Preliminary Consultation
MONTGOMERY COUNTY HISTORIC PRESERVATION COMMISSION
STAFF REPORT

Address:	7700 Seven Locks Rd., Bethesda	Meeting Date:	2/26/2020
Resource:	Master Plan Site #29/39 Gibson Grove AME Zion Church	Report Date:	2/19/2019
Applicant:	First Agape AME Zion Church (Thomas Taltavull, Architect)	Public Notice:	2/12/2019
Review:	Preliminary Consultation	Tax Credit:	N/A
Case Number:	N/A	Staff:	Michael Kyne
PROPOSAL:	Demolition and stabilization

Re: Structural Assessment Letter Report
First Agape AME Zion Church
7700 Seven Locks Road, Bethesda, MD 20817
DTSE Project No. 0054-003-01

DEMOLITION FLOOR PLAN

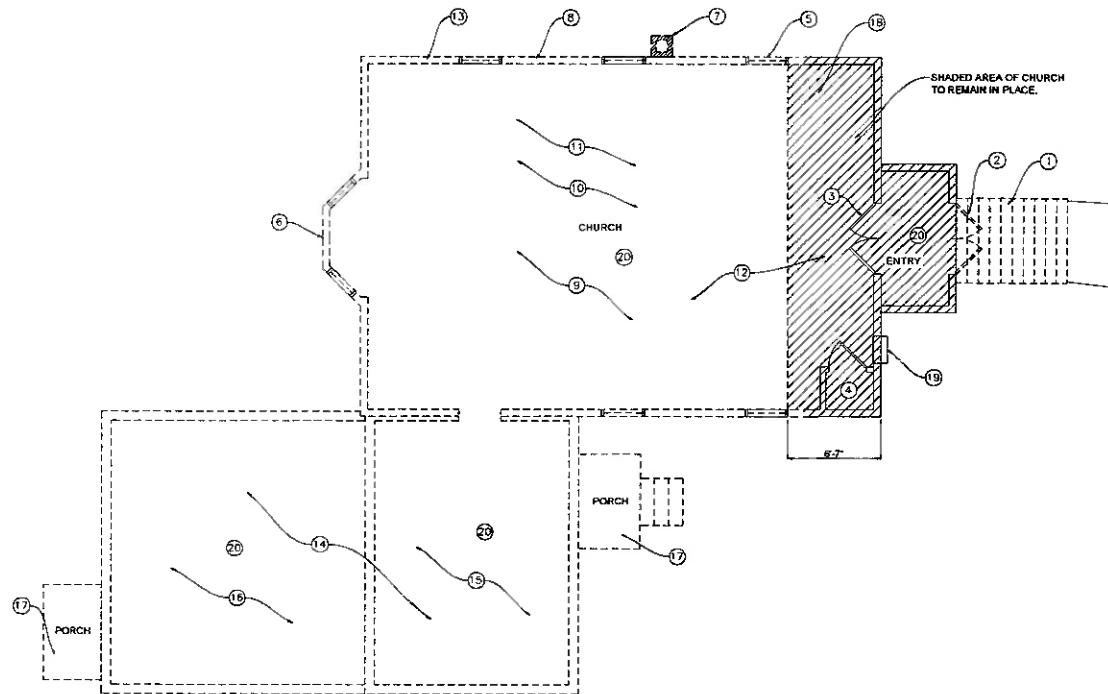
Given the information provided in the April 19, 2018 structural assessment, staff supports the applicants' proposal. When submitting a formal HAWP application, the applicants should include a complete stabilization plan, fully detailing how the remaining east end of the 1923 church building will be stabilized and weatherproofed. Additional information should also be provided regarding the means by which the existing building dimensions will be documented and how the retained windows, siding, and trim will be stored.

Staff asks the Commission to provide any additional guidance regarding the appropriateness of the proposal as well as any recommendations regarding the stabilization of the east end of the 1923 church building and/or storage of the retained materials.
